World Forum for Harmonization of Vehicle Regulations (WP.29)

Working Party on Pollution and Energy (GRPE)
(Forty-eighth session, 1-4 June 2004,
agenda item XXX)

PROPOSAL FOR A DRAFT AMENDMENT TO THE 05 SERIES OF
AMENDMENTS TO REGULATION No. 83
(Emissions of M1 and N1 categories of vehicles)

Transmitted by the experts from International Organization
of Motor Vehicle Manufacturers (OICA)

Comparison between the gears used according to ECE Regulation No. 83 and a possible manufacturer specific gear shift strategy

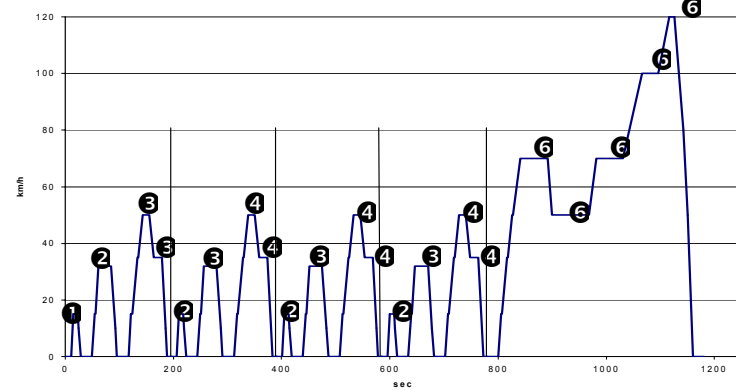
Since only the sixth gear could be used in replacing the fifth gear, the gear spreading of modern 6 speed gearboxes is not considered, which influences the gear shifting strategy also in the lower gears. The same problem occurs in principle with 5 speed gearboxes. The market penetration of

5 and 6 speed gearboxes today is nearly 100 percent. So the state of the art technology cannot be used in the way as it was designed for.

Steady speed in NEDC: 441 sec, i.e. 37%
 share 1. Gear during steady speed: 8,2%
 share 2. Gear during steady speed: 21,8%
 share 3. Gear during steady speed: 22,7%
 share 4. Gear during steady speed: 15,6%
 share 5. Gear during steady speed: 22,7%
share 6. Gear during steady speed: 9%

Steady speed in NEDC: 441 sec, 37%
 share 1. Gear during steady speed: 2%
 share 2. Gear during steady speed: 12%
 share 3. Gear during steady speed: 22%
 share 4. Gear during steady speed: 17%
 share 5. Gear during steady speed: 0%
share 6. Gear during steady speed: 47%

The manufacturer specific gear shift strategy as shown above is in line with the requirement of this Regulation, where in paragraph 2.3.2 of Annex 4 vehicles equipped with semi-automatic-shift gearboxes shall be tested by using the gears normally employed for driving.

Comparison of the up-shifting

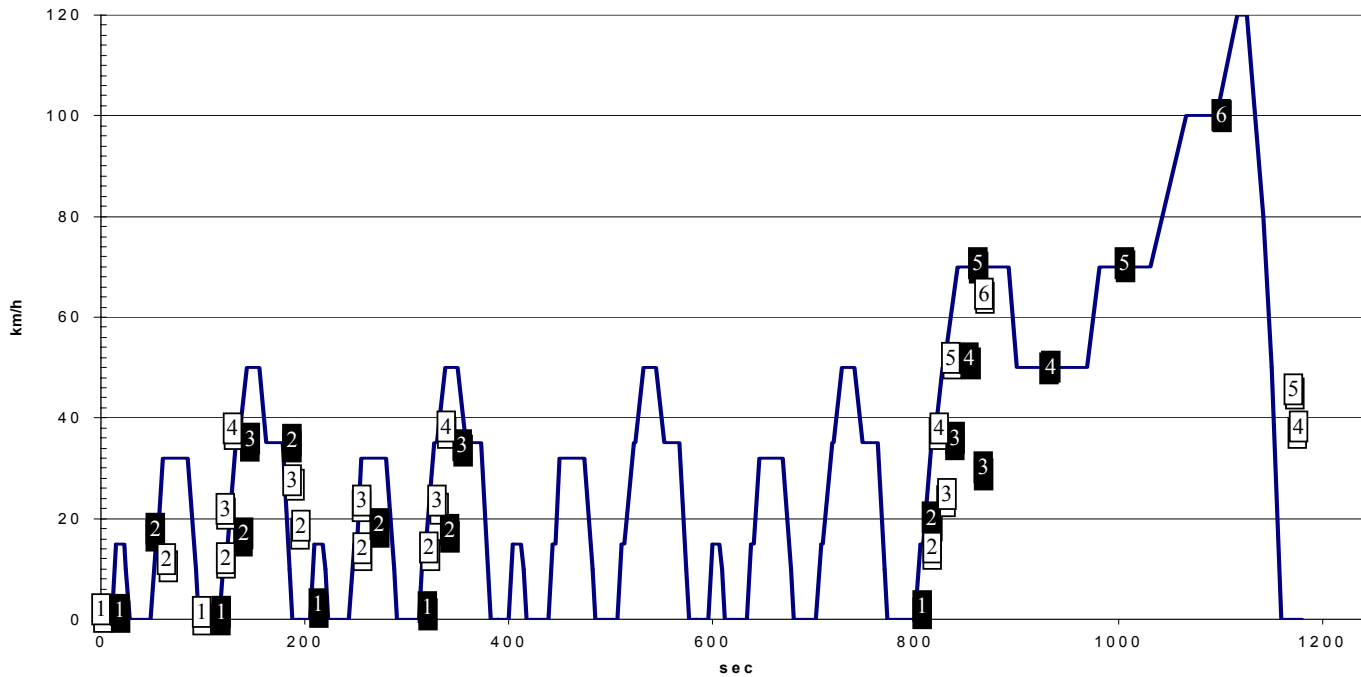
- 1.gear: 0-15 km/h
- 2. gear: 15-35 km/h
- 3. gear: 35-50 km/h**
- 4. gear: 50-70 km/h
- 5. gear: 70-100 km/h
- 6. gear: 100-120 km/h

- 1. gear: 0-13 km/h
- 2. gear: 13-23 km/h
- 3. gear: 23-36 km/h
- 4. gear: 36-52 km/h**
- 5. gear: 52-65 km/h
- 6.gear: 65-120 km/h**

An earlier up-shifting is possible with today's 6 speed gearboxes.

In addition to the requirement in paragraph 2.2.3. of annex 4, the shown gear shift strategy fulfils in addition the required tolerances as mentioned in paragraph 2.4. of annex 4. Both criteria should be the only limitation for a gear shift strategy.
